| NO. | DATE | DESCRIPTION |
|---|---|---|
| | 2026 11 05 | ISSUED FOR DP AMENDMENT |

**THE GRAND AND FIR**
181 ISLAND HIGHWAY, VIEW ROYAL, BC
2021-01

SITE PLAN, GRADE CALCS & FIRE DEPT. ACCESS PLAN

# A600
AMENITY PAVILION
PLANS & ELEVATIONS

1 **SITE PLAN**
A005 1:150

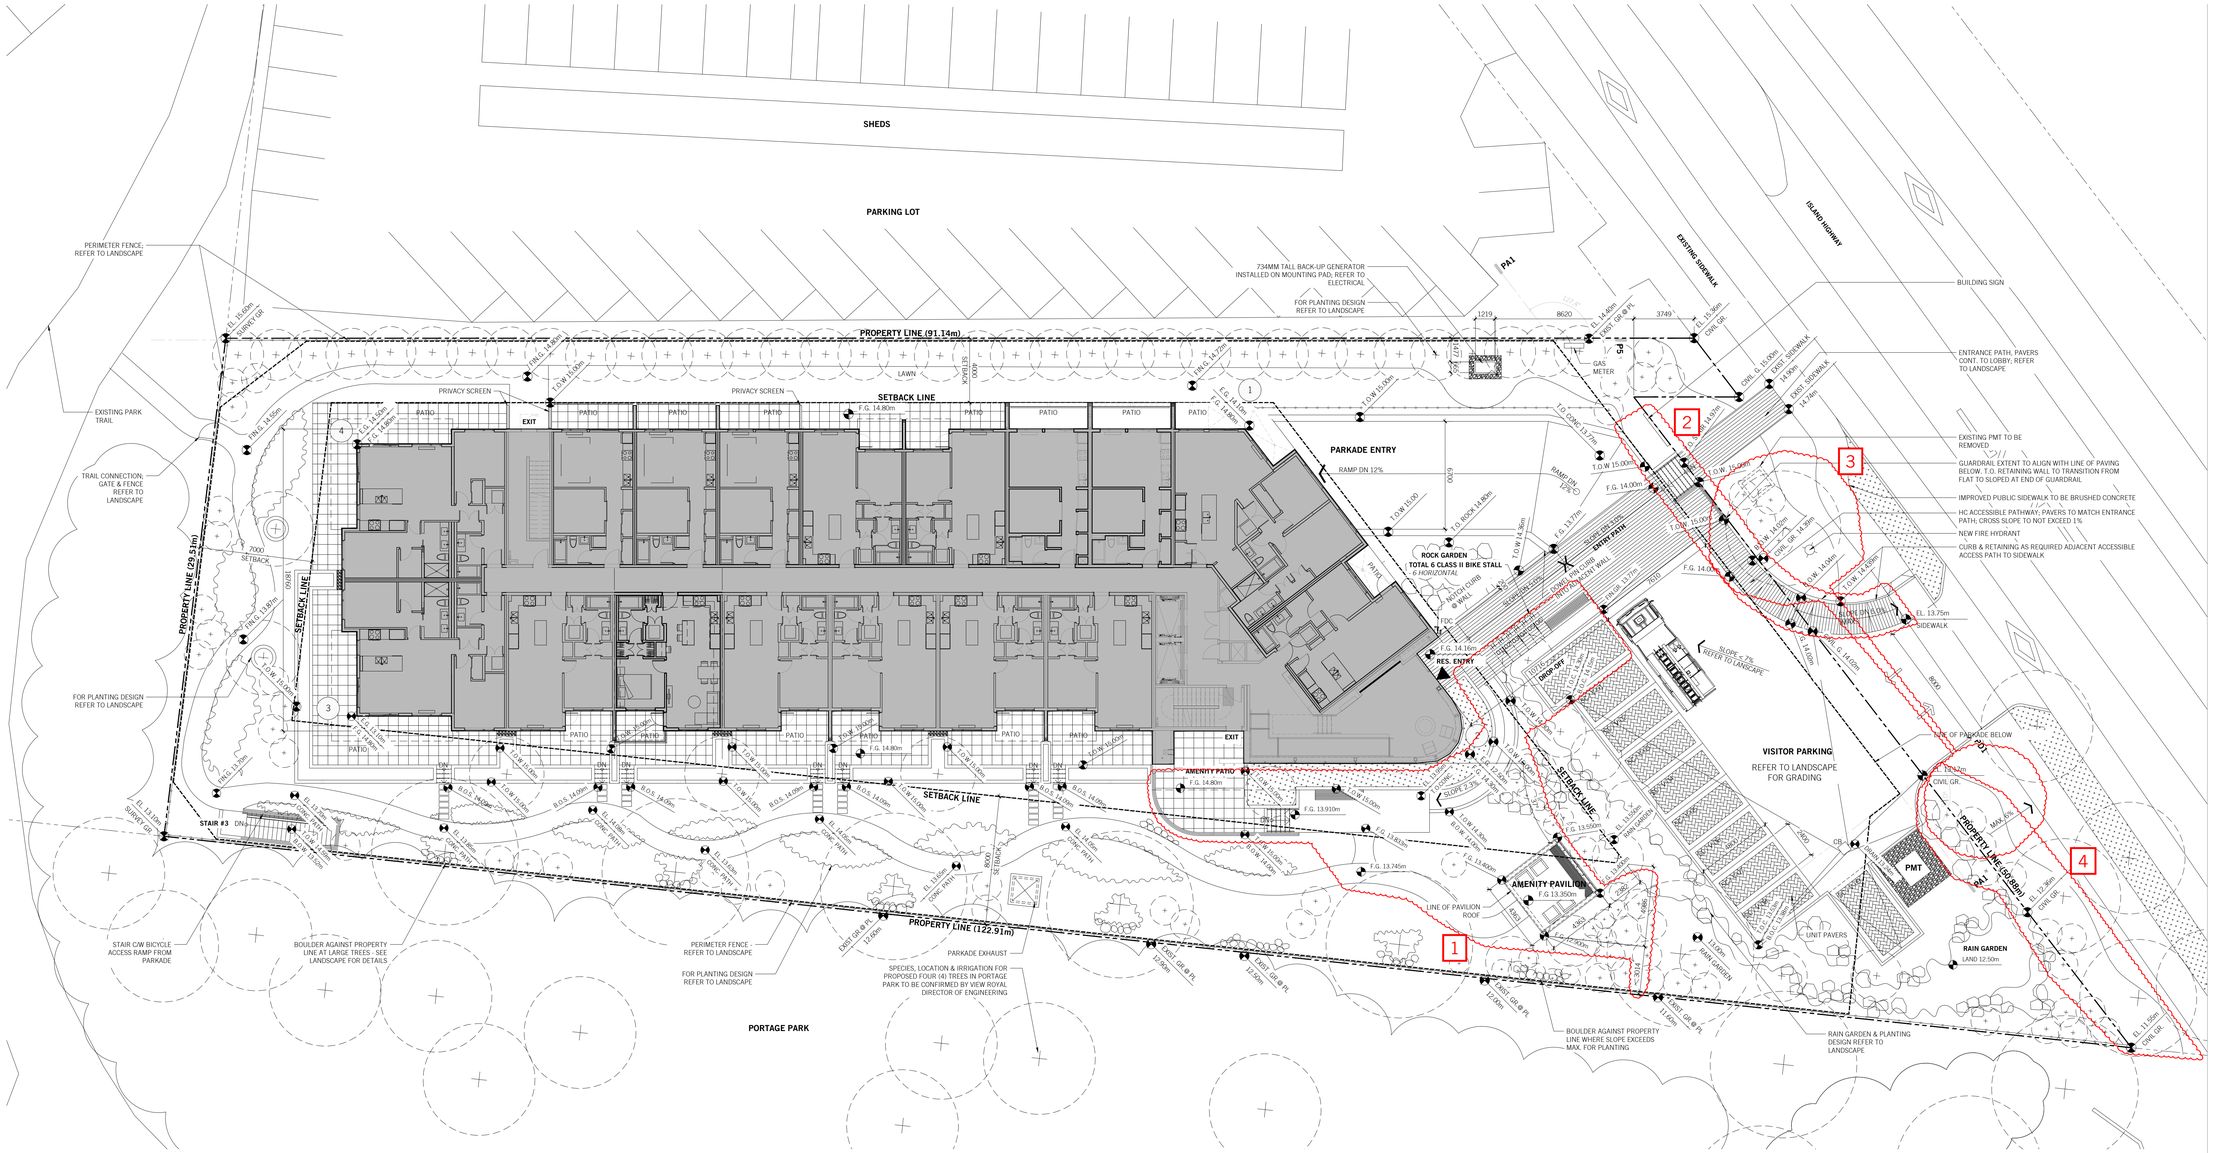
1 Revised pavilion design (see A600) and adjusted path connecting to it. Revised plan to include amenity patio, stairs, and accessible ramp for pavilion access

2 Revised building sign to west side of entry path. Accessible path from sidewalk, adjacent driveway entry, has been provided

3 Tree relocated to west side of driveway entry to match landscape drawings

4 Boulevard planting revised to match landscape drawings

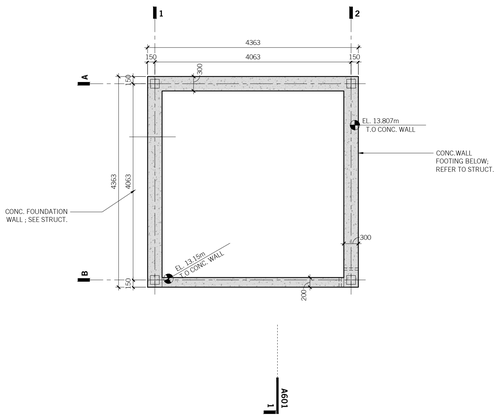
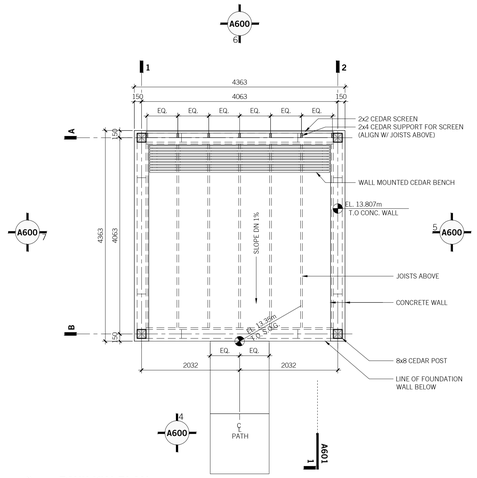
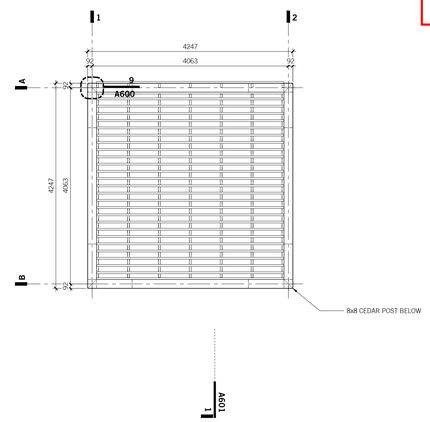
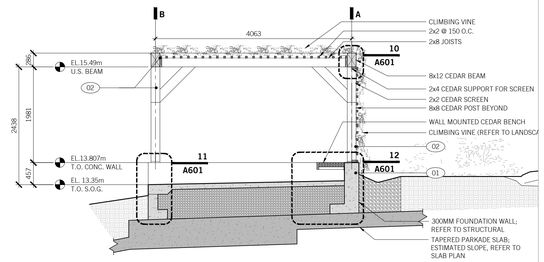
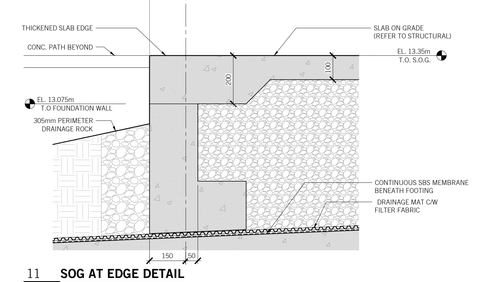
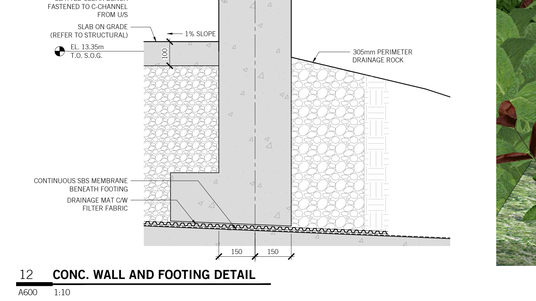
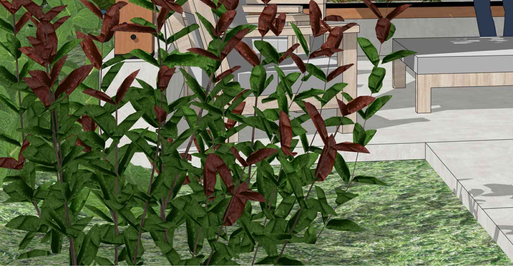
1 Revised Pavilion to be a contemporary pergola constructed of a western red cedar c/w with slatted roof for shade and slatted north facing wall to provide privacy from surface parking area as well as support plant growth. Provide built-in cedar bench with open area for flexible furniture layout. Top of roof elevation to be 15.776m (Previously 16.000m)
